From: Jean Dresden [REDACTED]
Sent: Thursday, December 10, 2020 11:50 AM
To: Davis, Dev <dev.davis@sanjoseca.gov>; Alanis, Diana <Diana.Alanis@sanjoseca.gov>
Subject: Google Slides with a little DSAP

A Few Big Ideas: DSAP

Google's *Downtown West Parks and Open Space*

Proposed General Plan Amendment

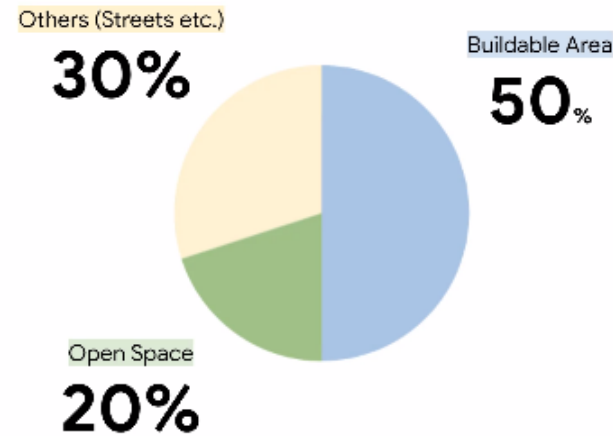
Convert Parks?

- LU-1.9 Preserve existing Public / Quasi-Public lands **or include parks and open space improvements in redevelopment projects** in order to maintain an inventory of sites suitable for Private Community Gathering Facilities, particularly within the Residential Neighborhoods, Urban Villages and commercial areas, and to reduce the potential conversion of employment lands to non-employment use. **Public / Quasi Public lands located within the Diridon Station Area Plan may be re-designated to other uses provided that such uses will advance San Jose's employment growth or housing goals and include parks and open spaces within the development.**

DISC Land Impact

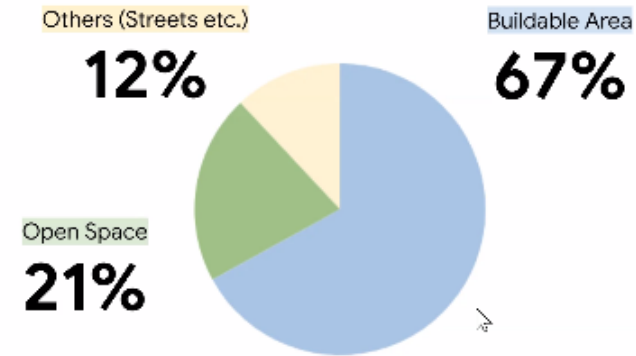
All DISC risk to SJ City dedicated parks

Total DISC Impact (~2.2 acres)

Trail Connection. City Dedicated. At risk of DISC.
Eminent domain's lower park valuation makes replacement unlikely.
Portion feels “private”

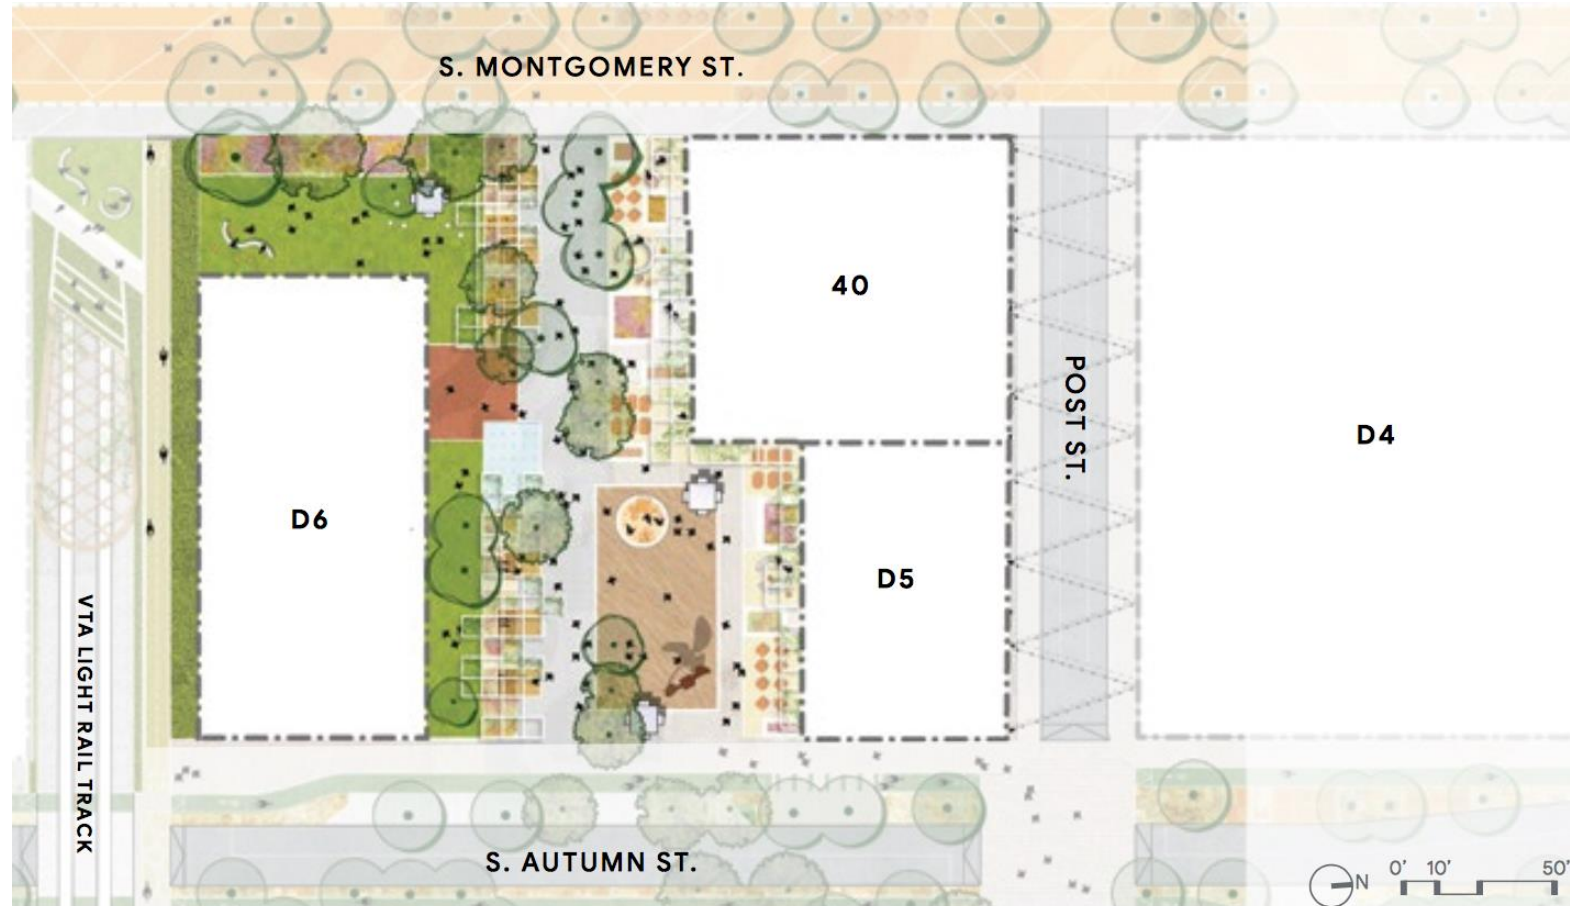
- Northend Park—1.43 acres City, 0.34 Google, 0.13 commercial.
Only active park, next to offices, DISC impacts, bisected by street

All spaces are a mix of ownership-
Who decides? Who operates? Who maintains?

FIGURE 4.43: Required and recommended Creekside Walk at South Autumn Street programmatic elements diagram

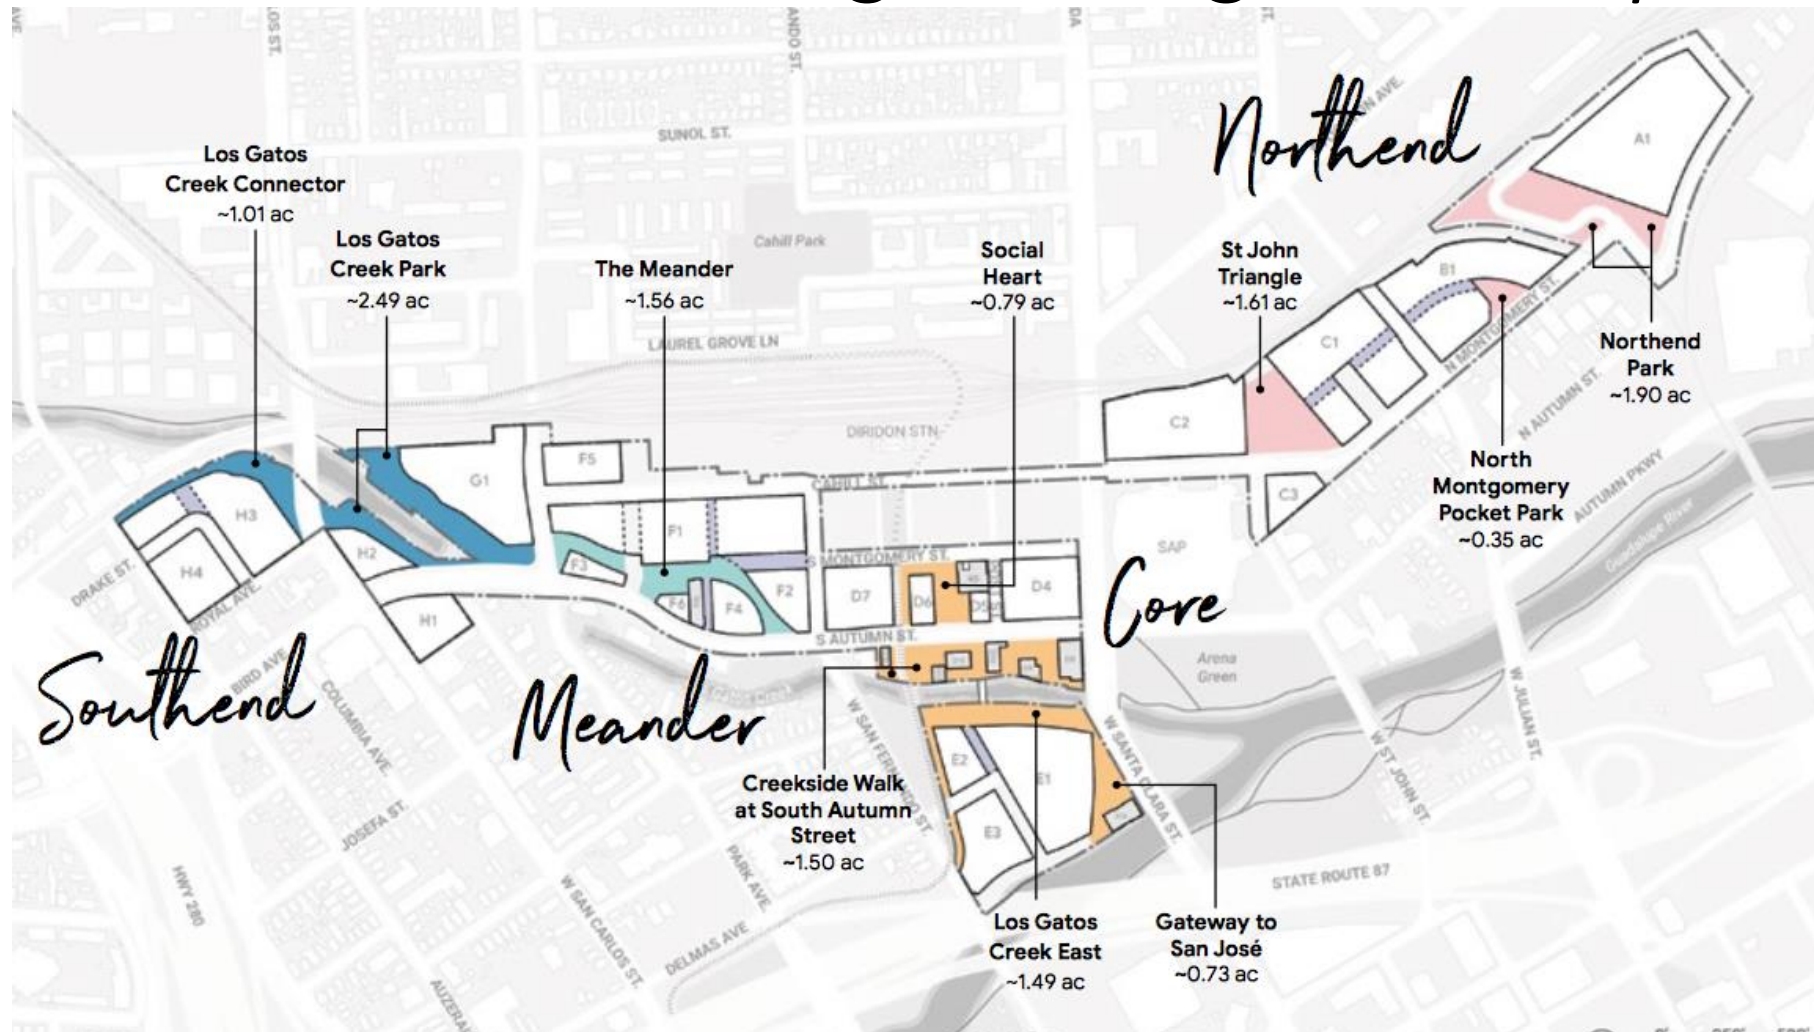
Social Heart: 0.57 acres City dedicated park, 0.22 “semi-public” commercial

Non-historic buildings—inside setback Replacements and additions planned Bridge violates riparian policies
